1/2.5-Inch 8Mp Digital Image Sensor

MT9E001

Silicon Revision 1 Errata

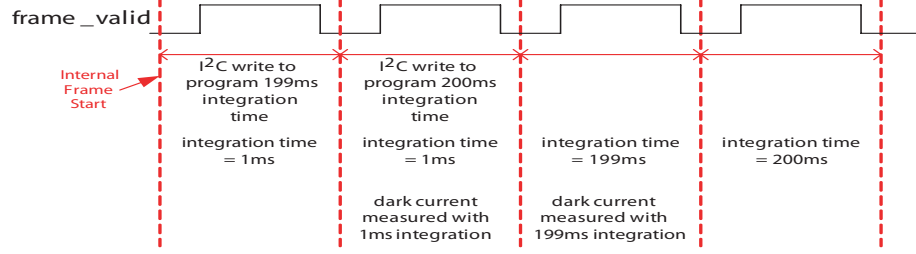
Issue#	Title Description Work Around	Details
2	Title	Dark current compensation.
	Description	<p>An integration time change will take effect on the second frame after the integration time register was programmed. However, the delta dark algorithm will use the first frame after the integration time register was programmed to measure the dark current. Hence, the delta dark algorithm will compensate for dark current based on the old integration time instead of the new integration time. This will be noticeable for large integration time changes as the dark level calculated for the new integration time will use the frame prior to when the new integration time was used.</p> 
	Work Around	<p>The integration time is changed in two successive frames where the first frame's integration time is only slightly different from the second. In this case, the dark level calculated for the second frame uses the prior frame that has a similar integration time, producing a very small difference in dark level. An example would be a change from 1ms to 199ms, and then to 200ms, where the ongoing dark level for 200ms would be calculated from a frame using 199ms. If the gain setting is also being changed, it should not be applied on the first of the two consecutive frames. An example is shown in the graphic below.</p>
